**TOWN OF NEWBURGH
PLANNING BOARD
TECHNICAL REVIEW COMMENTS**

PROJECT: NPA SITE PLAN
PROJECT NO.: 17-03
PROJECT LOCATION: SECTION 89, BLOCK 1, LOT 80.2 & 80.1
REVIEW DATE: 14 JULY 2017
MEETING DATE: 20 JULY 2017
PROJECT REPRESENTATIVE: ZEN DESIGN CONSULTANTS

Re: NPA Site Plan
747 Blvd

Comments addressed from McGoey, Hauser & Edsall, dated 01/16/2017:

ENGINEER WILLIAM J. MOREAU	PROPOSED SITE PLAN NEWBURGH PARK ASSOCIATES, INC. EXISTING SITE PLAN SBL: 89-1-19.22 TOWN OF NEWBURGH, ORANGE COUNTY, NY		
DATE 7/7/2016	SCALE 1"=30'	JOB NUMBER 15-008-PMU	SHEET NUMBER 1 OF 2

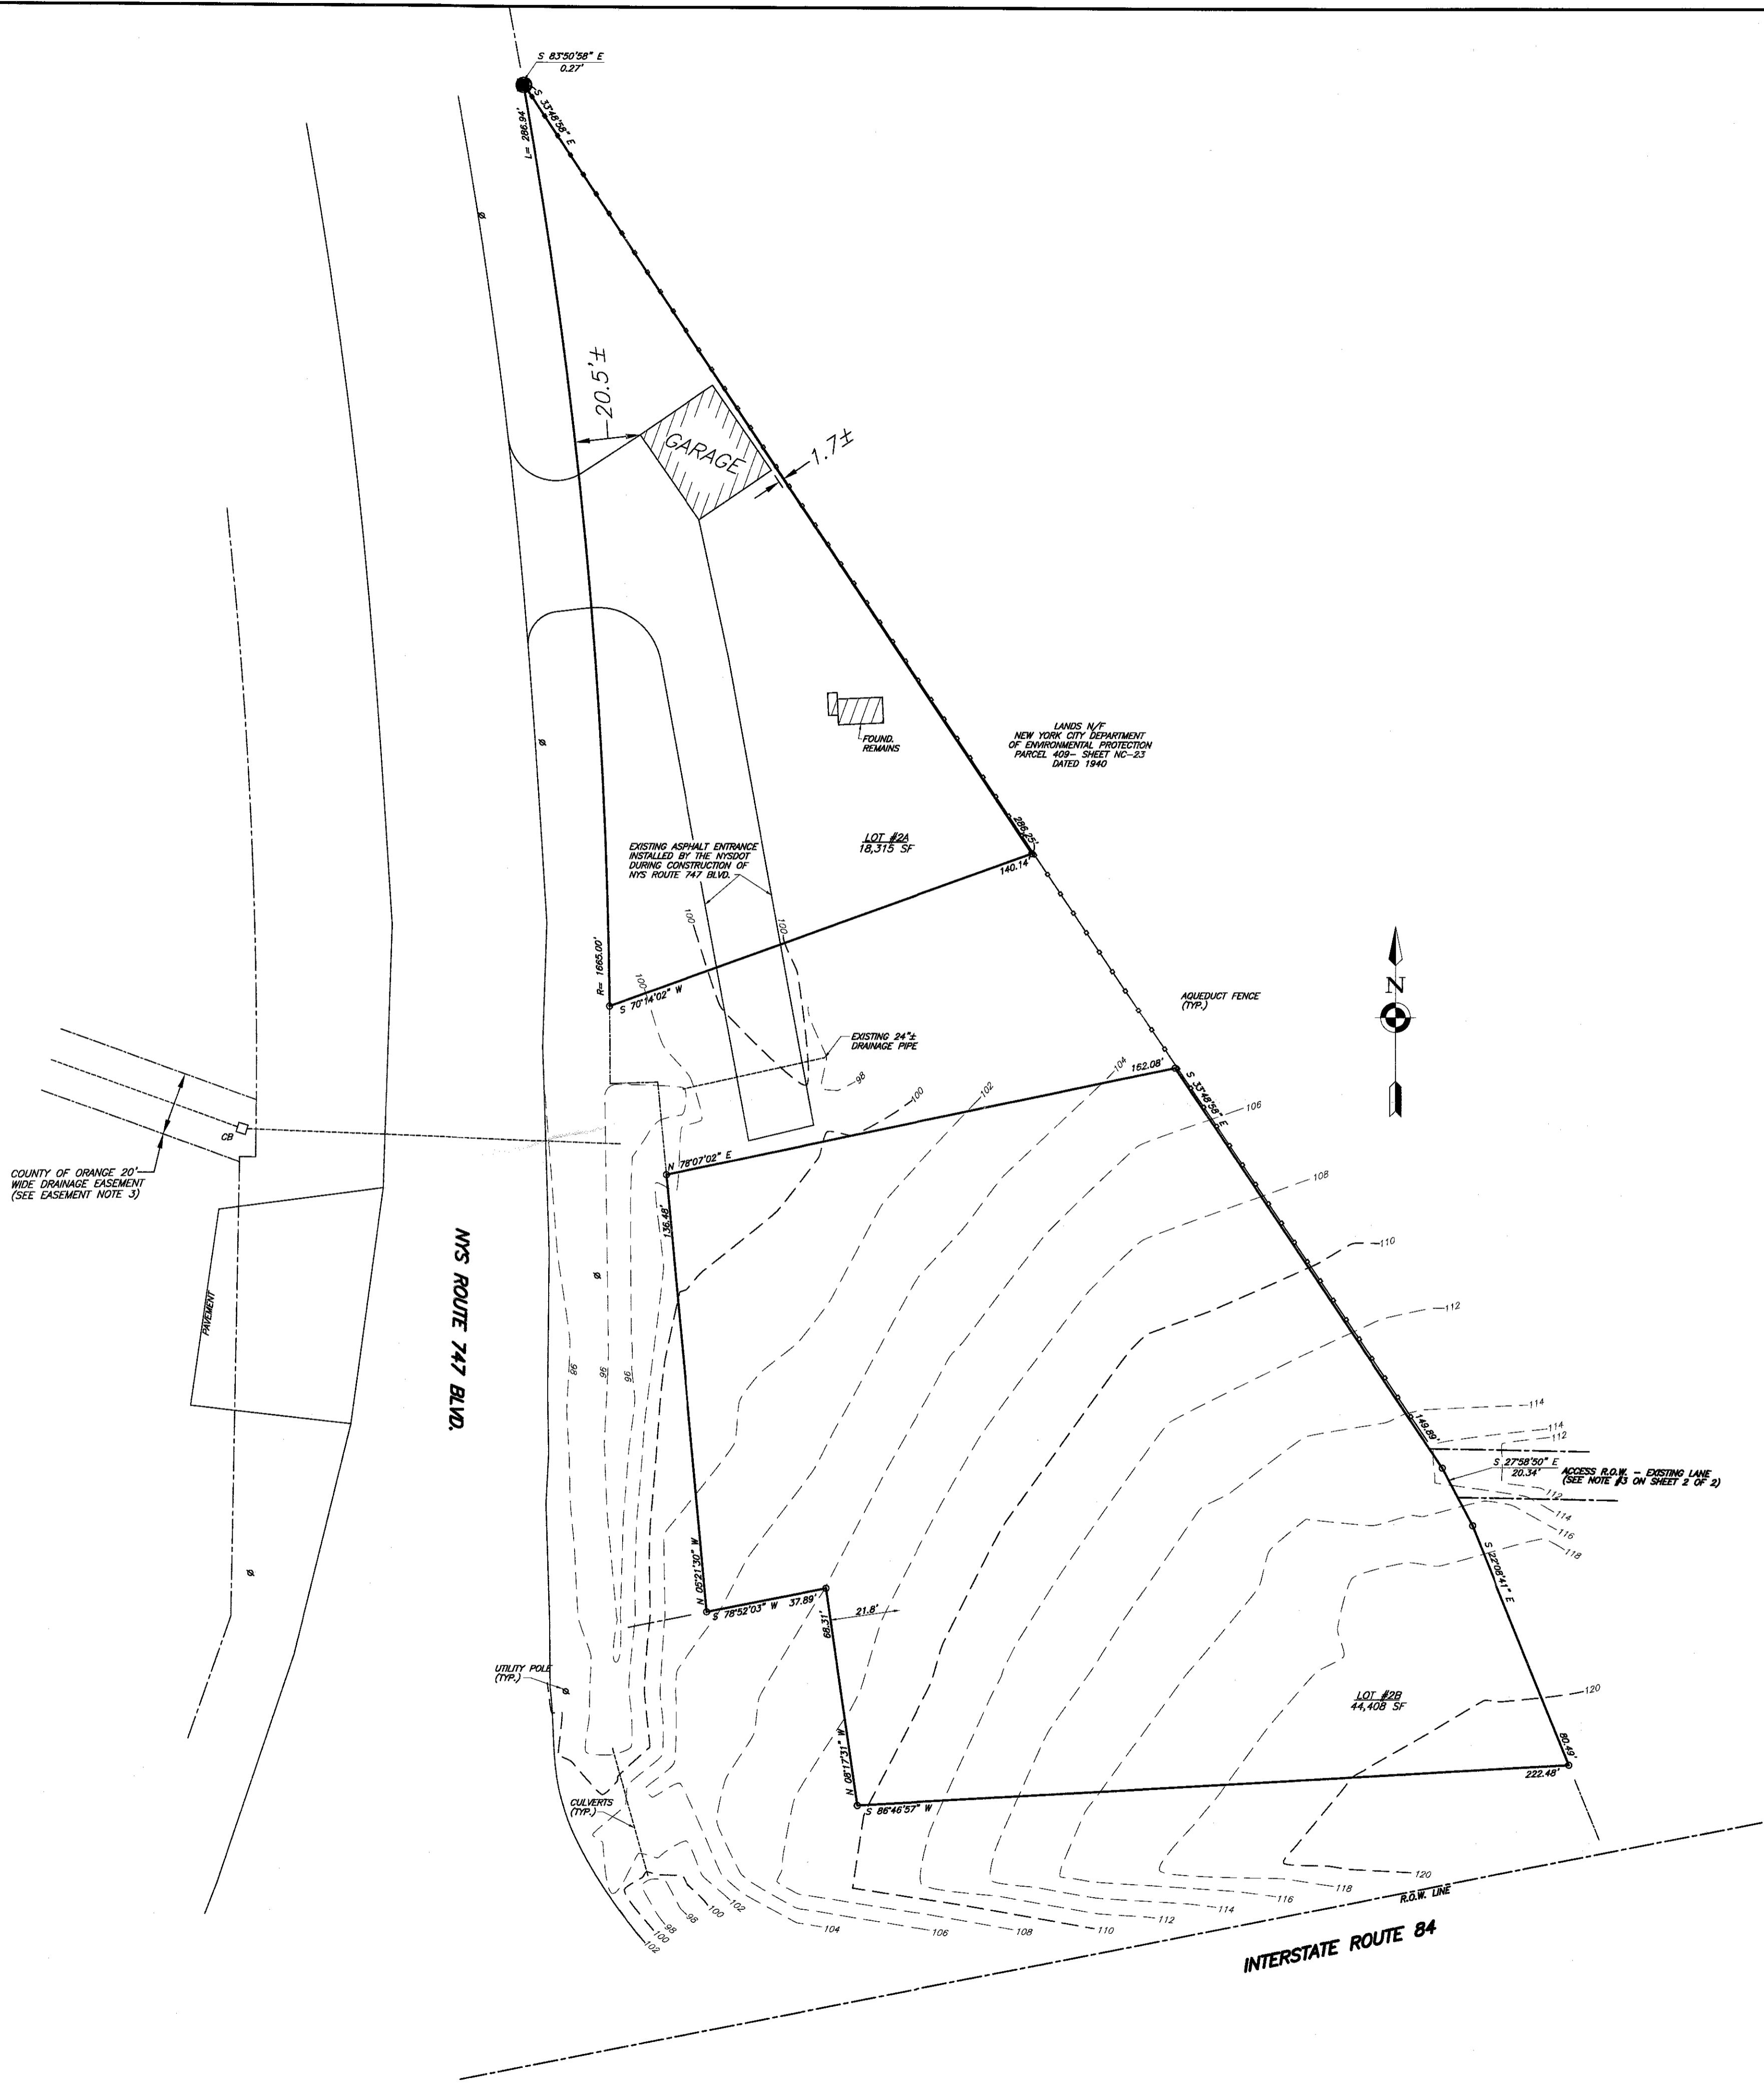
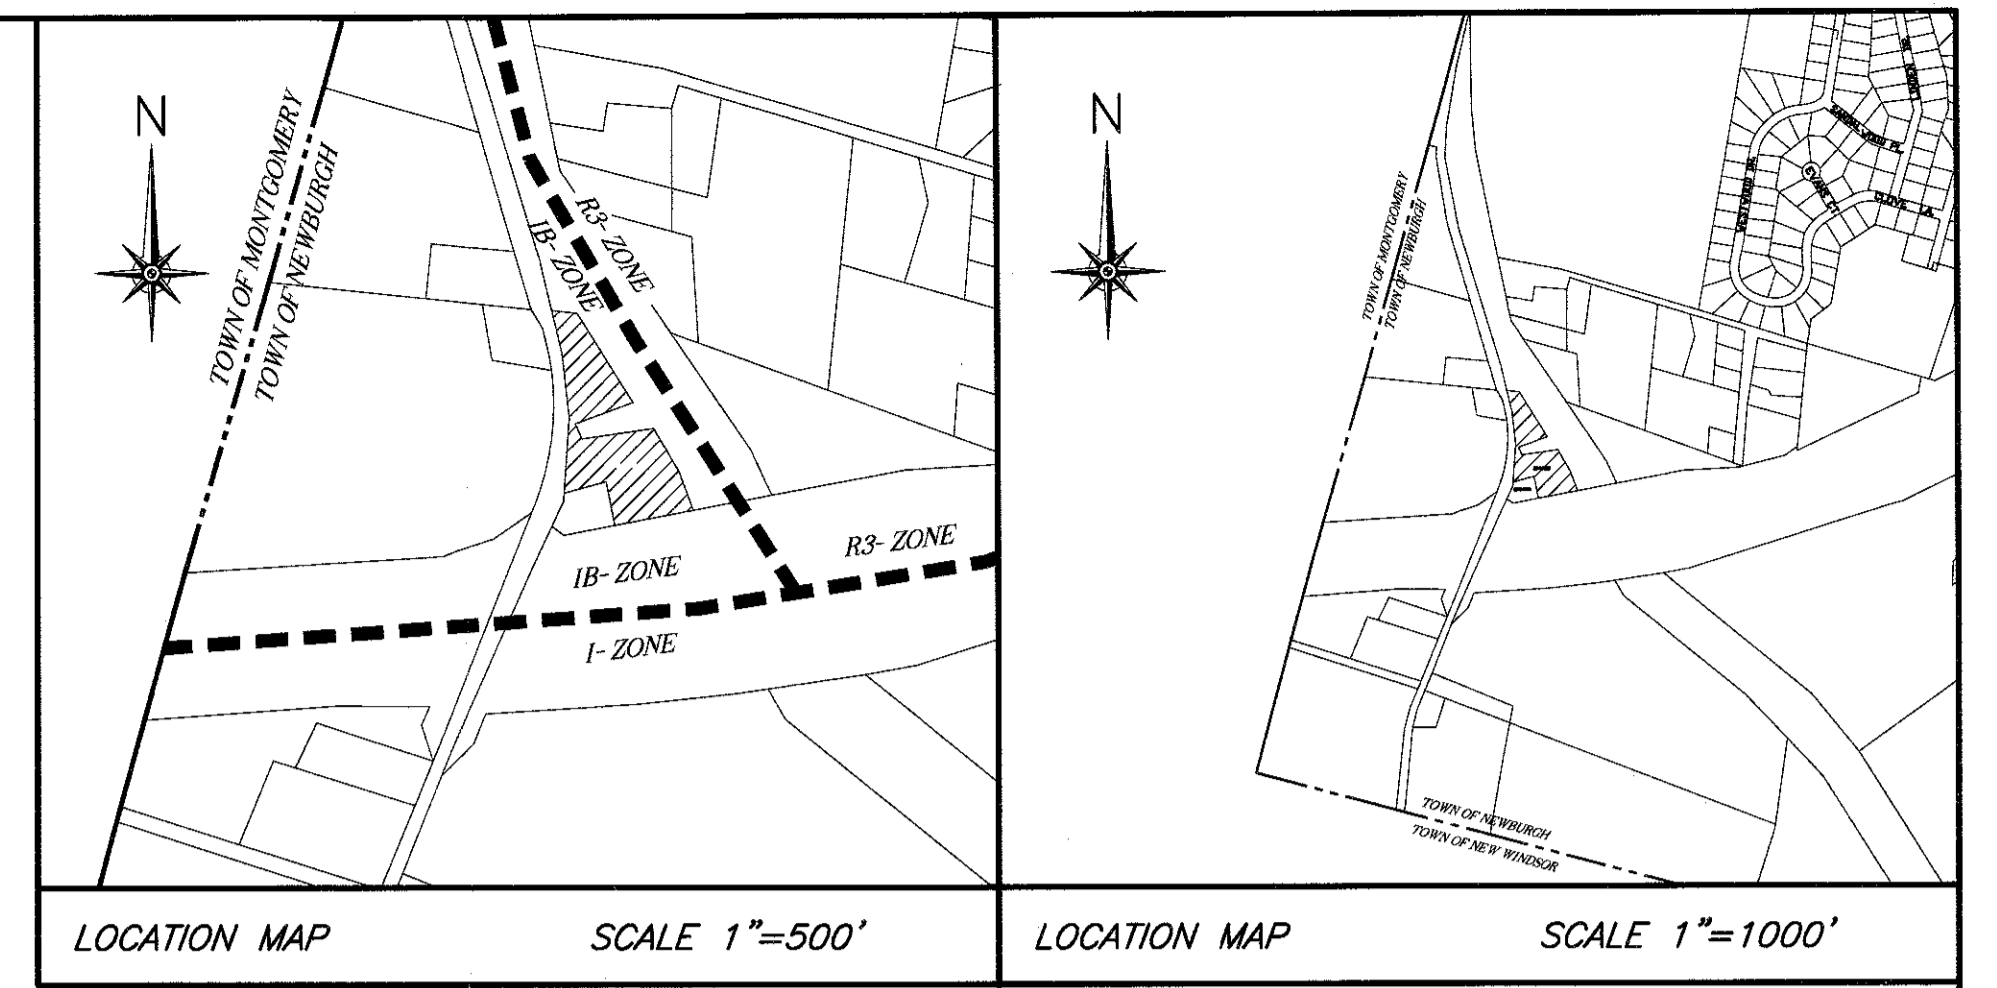
1. Bulk Table for the IB zone appearing on Sheet 1 of 2 should be corrected for IB District Schedule 8D(2) set back requirements.
This has been corrected on the plans.

2. Plans should clearly label each of the lots referred to on notes 1-3 of sheet 1 of 2. Lots 2a, 2b and 2 are referenced, however lots 2a and 2b are labeled.
I have attached a copy of the previous subdivision map which should help to clarify these notes.

4. Plans should identify the point of access to the proposed development. Currently plans stop short of depicting access onto the State Highway. Bulk tables should include all minimum and maximum required items in Schedule 8.
Access point onto 747 Blvd has been added to the plans. Bulk tables have been adjusted to show all requirements.

5. The lot is considered a corner lot in accordance with Section 185-17. Both street frontages are front yards while one of the other shall be deemed a rear yard and side yard. These should be clearly labeled with dimensions.
This has been adjusted on the plans.
